TOWN OF LOS ALTOS HILLS
Staff Report to the Planning Commission

November 6, 2014

SUBJECT: SITE DEVELOPMENT PERMIT FOR A LANDSCAPE SCREENING PLAN FOR A TWO STORY NEW RESIDENCE; LANDS OF VAHDAT; 26520 PURISSIMA ROAD; FILE # 156-14-ZP-SD (CONTINUED FROM OCTOBER 2, 2014)

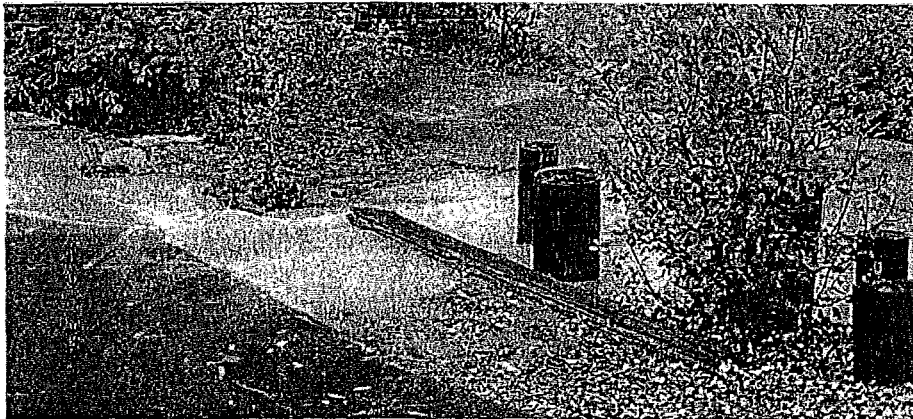
As a result of the developed area at 26462 Purissima Road which is a few hundred feet up-stream from the 26520 Purissima Road lot, existing driveway culverts have been overwhelmed.

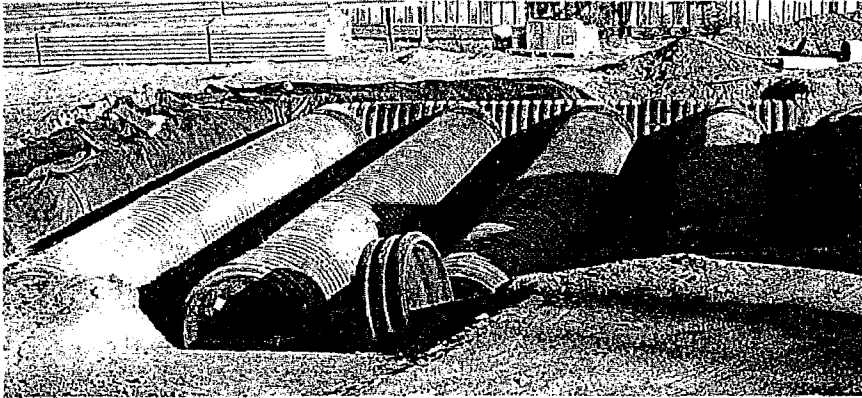
Since rain runs off impervious surfaces quickly, causing flooding, new building requires temporary storage of burst rainfall

That is why the county required these pipes to be installed at 26462 Purissima Road.
